MEMORANDUM

Subject: **Bottle Bay Recreational Water and Sewer District**, Addendum to Reuse Permit LA-000015-04 (Municipal Wastewater), Staff Analysis for Permit Modification

The purpose of this memorandum is to satisfy the requirements of the Idaho *Recycled Water Rules*, IDAPA 58.01.17.400.05 and 58.01.17.700, for issuing a modification to an existing reuse permit. This memorandum addresses the draft, Addendum 'A' to Reuse Permit LA-000015-04, for the municipal treatment and recycled water system owned and operated by the Bottle Bay Recreational Water and Sewer District (BBRWSD).

Figure 1, Site Map

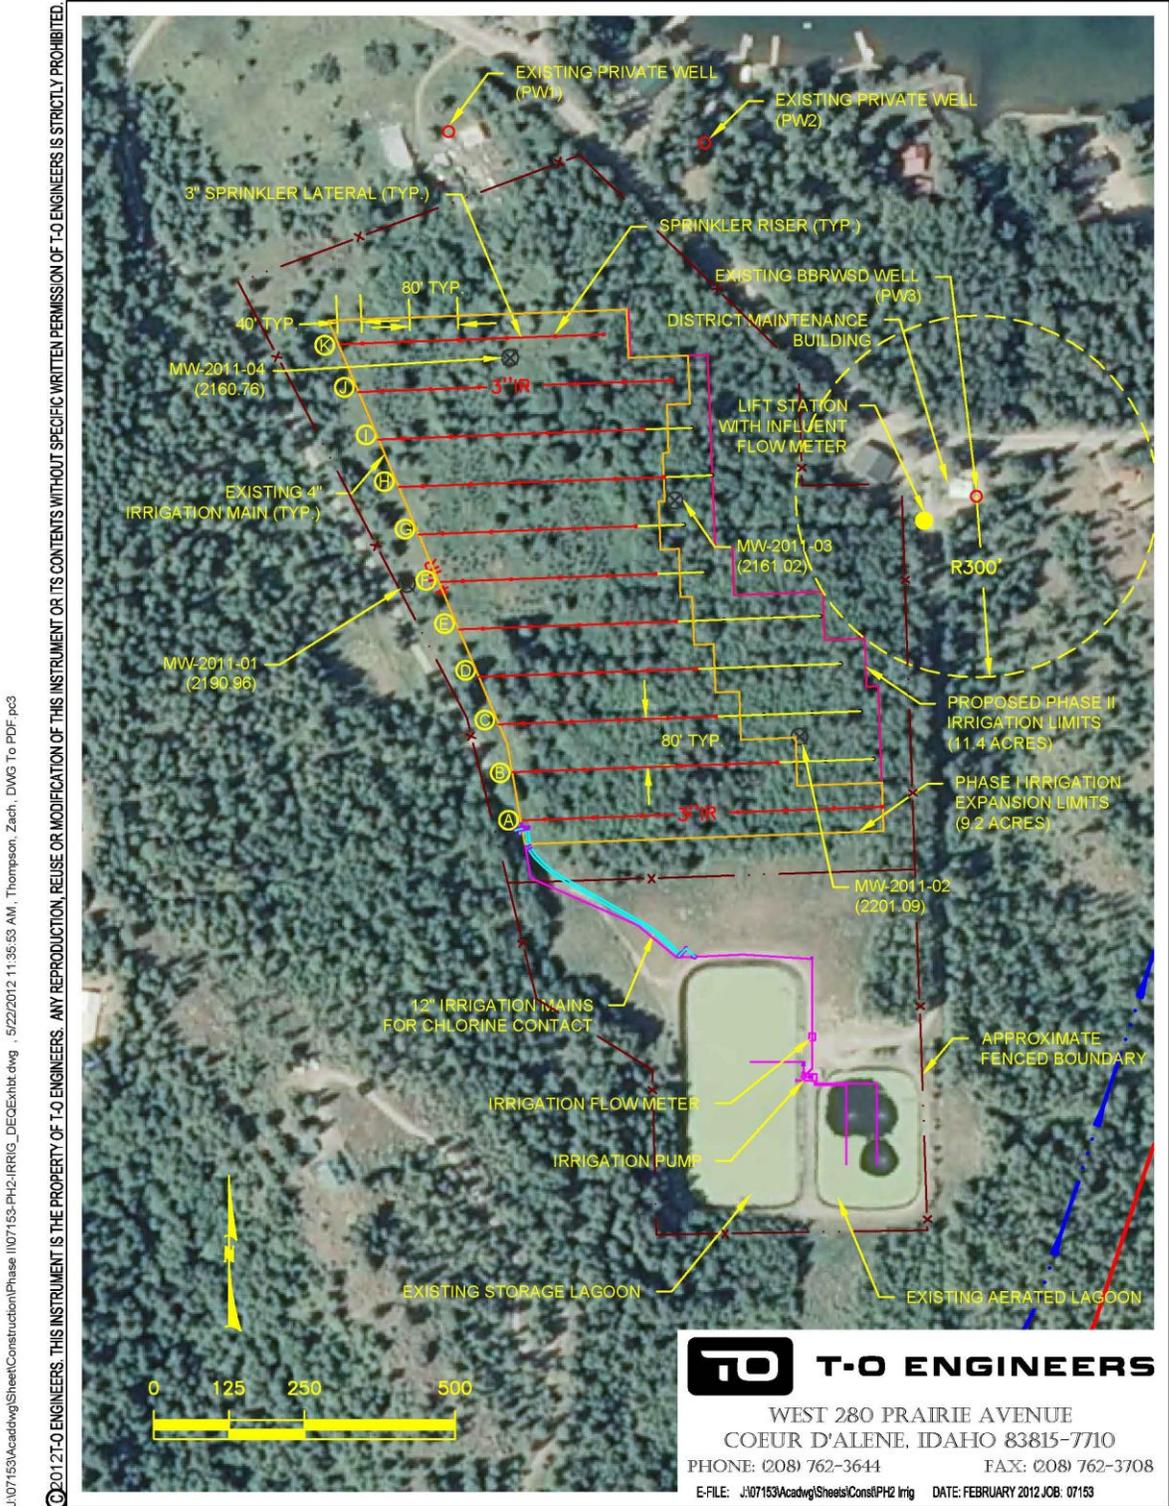
The BBRWSD wastewater facilities are described in the 2009 "Staff Analysis" (DEQ, 2009). Four (4) dedicated ground water monitoring wells were constructed in June 2011, as required by compliance activity CA-015-06 in the 2010 Permit (see Figure 1, Site Map).

The proposed irrigation system expansion would change the buffer distance between the irrigation site and the drinking water well at the BBRWSD maintenance building (PW3 on Revised Site Map in Appendix 3) from 500 feet (currently) to 300 feet (proposed). PW3 is monitored annually in October as required in the current reuse permit (GW-001507 is the serial number for this well in the permit). The buffer distance to Lake Pend Oreille will continue to be about 450 feet. Buffer distances to homes and public access areas will remain the same.

The dedicated monitoring wells were constructed in June 2011 so only the September 2011 ground water monitoring sampling event included the new monitoring wells (see Figure 1, Site Map for well locations). The September 2011 ground water monitoring results in the

- 1) The completion of the monitoring wells requires a change in the “Ground Water Monitoring” table in Appendix 1, “Environmental Monitoring Serial Numbers” of the 2010 permit. See Figure 1 for the locations of the monitoring wells. The table in the permit will be modified as follows:

- 1) It is recommended that the buffer distance between the expanded irrigation site and the BBRWSD maintenance building (PW3 or GW-001507) be reduced from 500 feet to 300 feet based on the DEQ Guidance “Well Acceptability Analysis”, current water quality data from PW3 and the use of dedicated monitoring well upgradient from PW3 to provide early warnings of negative impacts to PW3.
- 2) No changes are recommended from the previous permit to other buffer zone distances.
